SNUPPS

March 20, 1984

SLNRC 84-0046 FILE: 0543
SUBJ: SNUPPS Technical Specifications

Revised Technical Specifications
and Justifications

Figure 2 Wolf Creek Reactor Coolant System Cooldown Limitations
Applicable up to 16 EFY

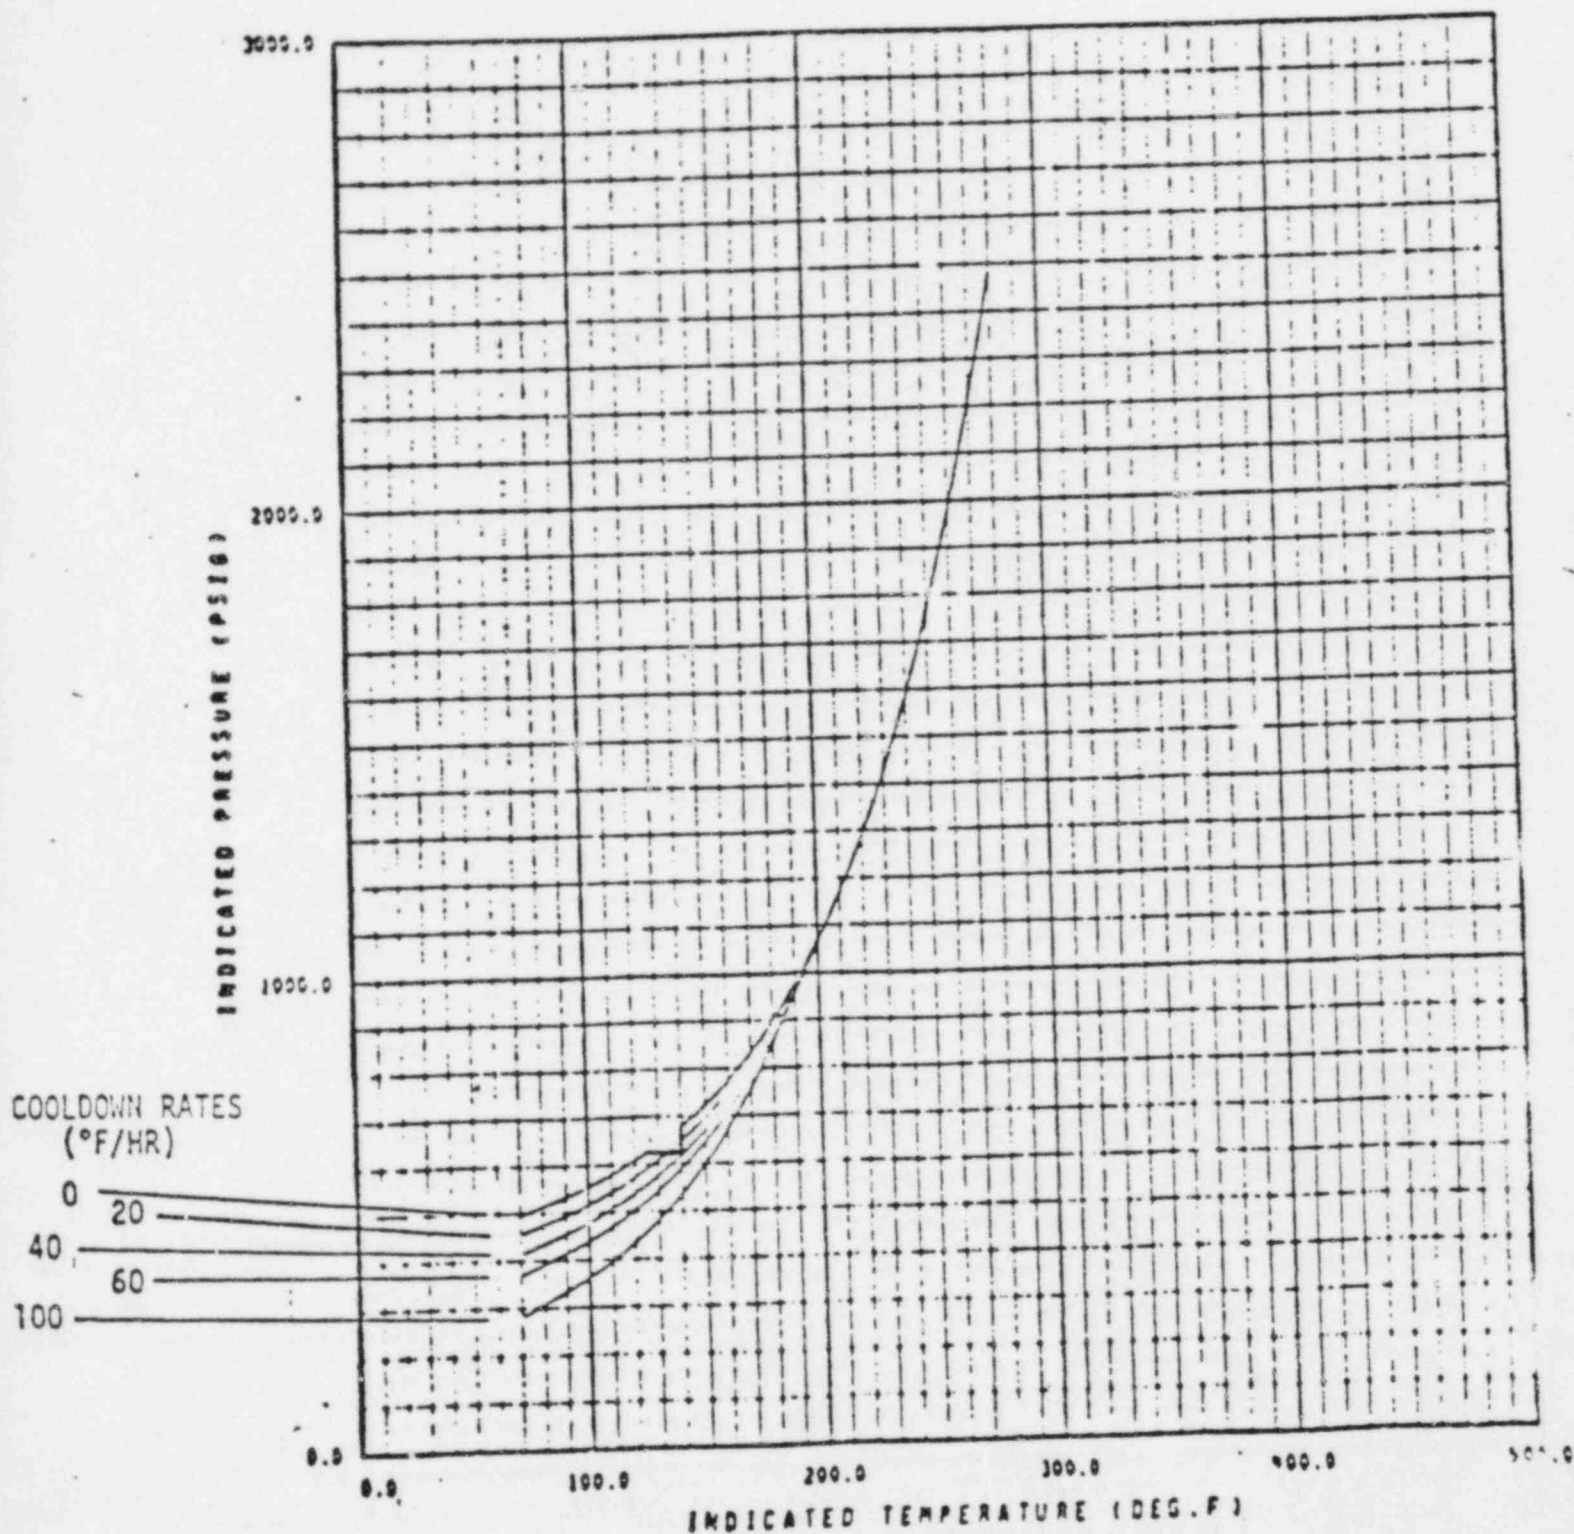
3.4.9.3 3.8.1.2 3.8.2.2 3.8.3.2	RHR Suction Relief Valves	Justify use of the RHR suction relief valves for cold overpressurization protection.	NRC provide final approval of the proposed changes.
Fig. 3.4-3	RCS Cooldown Curves	Provide cooldown curves for Callaway and Wolf Creek.	Included in Attachment 2
